Proposed Cruise Berthing Facility, Grand Cayman
Environmental and Engineering Consultancy Services
Environmental Statement
Appendix A - Alternatives Assessment

**Ministry of District Administration Tourism & Transport
and The Port Authority of the Cayman Islands**

APPENDIX A.4 - PRELIMINARY TECHNICAL REVIEW OF FLOATING PIER CONCEPT

Figure 4.1 – Schematic Rendering of Floating Pier Concept

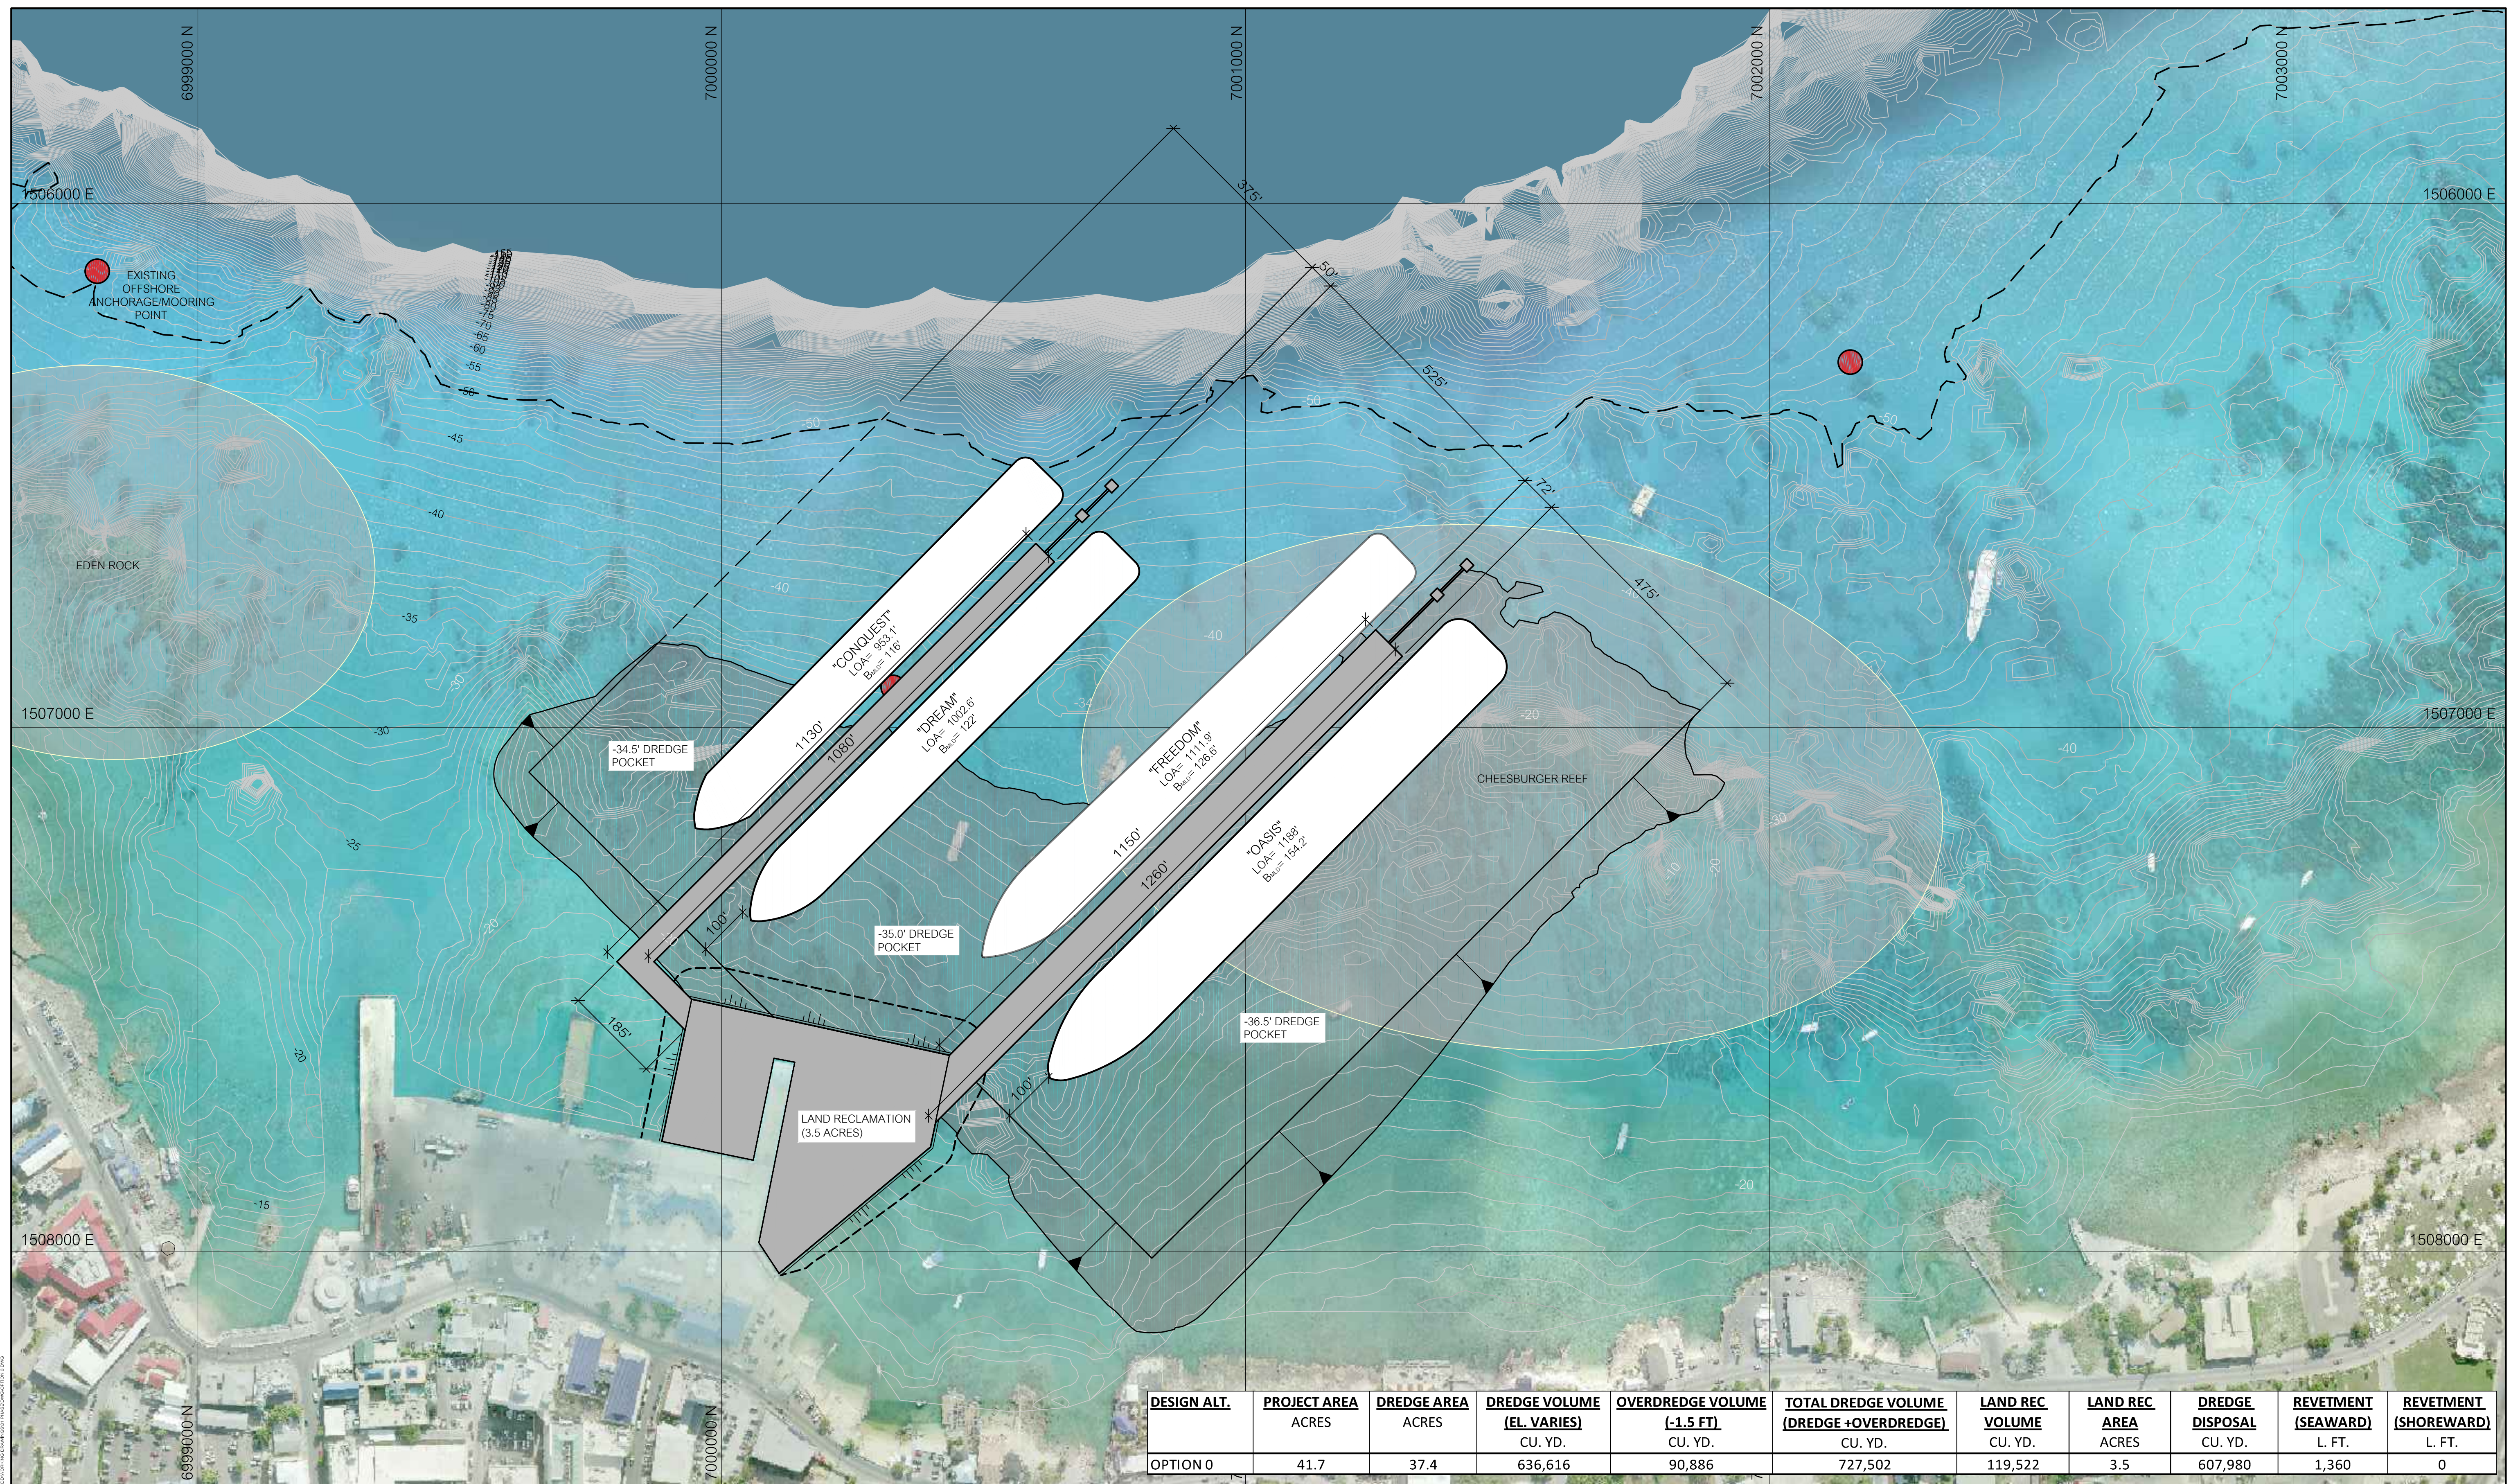
Baird agrees that a floating pier may cause less damage to corals than a fixed pier, particularly if dredging can be avoided by shifting the piers into deep water. However, Baird is concerned that the project concept may not be technically feasible without dredging, specifically due to the requirement to robustly anchor the piers in very deep water off "The Wall". This critical technical challenge is discussed in more detail later in this letter.

Baird agrees that the floating pier concept would have a reduced visual impact, assuming it can be designed to berth the cruise ships further offshore. However, as noted above, Baird is concerned that the project concept may not be technically feasible with the piers extending beyond “The Wall”, due to challenges associated with designing a sufficiently robust anchoring system in very deep water. This critical technical challenge is discussed in more detail later in this letter.

At the Chamber of Commerce meeting on October 28, 2014, the Proponent noted that the access pier (900 ft long) would be fixed, and that the outer three floating arms (each 900 ft long) would be anchored with “tension legs” and submerged during rough weather (Nor’Westers, tropical storms and hurricanes) in order to reduce their exposure to wave action. As discussed later in this letter, Baird has a number of questions/concerns regarding this approach.

- Based on the information presented at the Chamber of Commerce meeting on October 28, it is understood that the access pier will extend 900 ft from shore to the arrivals hall, with three 900 ft long “finger” piers extending radially out from the arrivals hall. Based on these dimensions, the outer ends of the piers, and the associated anchors, will be located beyond “The Wall”, potentially in water depths in excess of 500 ft (a scale drawing of the proposed concept is required to confirm this). The ability to design a suitable anchor system to restrain the piers and resist the significant loads associated with winds, currents and waves acting on the cruise ships is questionable. Further, the installation of anchors on a steep slope at these depths would be very challenging **(Baird opinion: possible fatal flaw)**.

location in advance of such an event, and the second being to submerge the pontoons to reduce the hydrodynamic loads to which they are exposed. Regarding the first approach, Baird does not believe that this is a practical solution, given the size of the structure (reported to be twenty pontoons, each measuring 300 by 75 by 25 ft) and the lack of a suitable sheltered water area around Grand Cayman. Regarding the second approach, Baird does not believe that submergence will provide a significant reduction in the hydrodynamic loads during severe storm events, as discussed further in Attachment A (**Baird opinion: possible fatal flaw**).

- The major cruise lines all have ships with overall lengths (LOA) in excess of 1,000 ft, with the largest being the Oasis (LOA = 1,187 ft). A 900 ft long pier is not long enough to accommodate typical mooring arrangements for these vessels, in particular the bow and stern lines, which ideally should be aligned at 45° to the axis of the ship. Hence, longer piers may be required (**Baird opinion: design detail**).

- Recent meetings with representatives from four cruise lines highlighted the preference for a NW pier orientation, with one cruise line stating they would not use a facility that had W or SW pier orientations. The floating pier concept, as presently proposed, includes three piers, with NW, W and SW orientations. A revised layout may be required to meet the requirements of the cruise lines (**Baird opinion: design detail**).

- Typical navigation requirements dictate a minimum separation of four times the beam of the design vessel between piers. A refined layout for the floating pier concept may be required to provide sufficient space between the piers for safe navigation (**Baird opinion: design detail**).

- The schematic renderings show an arrivals hall on the pier, but no additional land area. Additional land area may be required to support the expanded cruise berthing facility. The cost to create additional land area may be significant, particularly given the lack of dredged material to use as fill (**Baird opinion: design detail**).

- The floating pontoons are reported to be 25 ft high; assuming a deck level of 10 ft above sea level (typical for cruise ship piers), the pontoon draft would be 15 ft. As a result, the pontoons would block flow in the upper 15 ft of the water column, forcing the flow to pass under the pontoons. Conversely, a pile-supported pier would allow flow throughout the water column, although there would be intermittent blockage due to the piles. The relative impacts of the two pier concepts on nearshore hydrodynamics and circulation is not known at this time (**Baird opinion: design detail**).

Based upon the information available at this time regarding the floating pier concept, Baird questions whether the concept is technically feasible. That being said, it is suggested that the Proponent be provided with the opportunity to respond to the technical issues raised in this letter, as it is possible that they may have a strategy to address them. If the Proponent is able to demonstrate, with relevant supporting information, that it is confident that it can address the key technical issues discussed herein, it is suggested that they be invited to submit a full proposal to the Request for Proposals for Design-Build-Finance Tenders when it is issued.

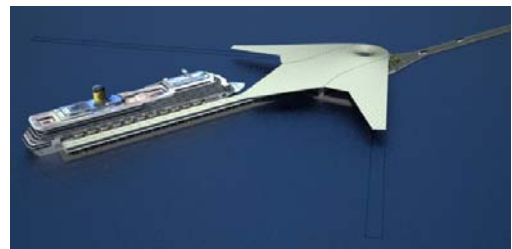
The Proponent suggests that the floating structure could be repositioned during rough weather. While this is possible, several questions arise, including the identification of a suitable “safe haven” for the pontoons, and the logistics (manpower, equipment and time) required to detach, tow and store the pontoons, and subsequently re-install them. For example, while a location on the South Coast might provide sufficient protection from Nor’Westers, it is understood that these events are not easy to predict, and can develop with very little warning. Also, considering tropical storms and hurricanes, there is some uncertainty in forecasting storm tracks, thereby resulting in uncertainty and risk in the selection of a suitable “safe haven” for the pontoons in the face of a approaching storm.
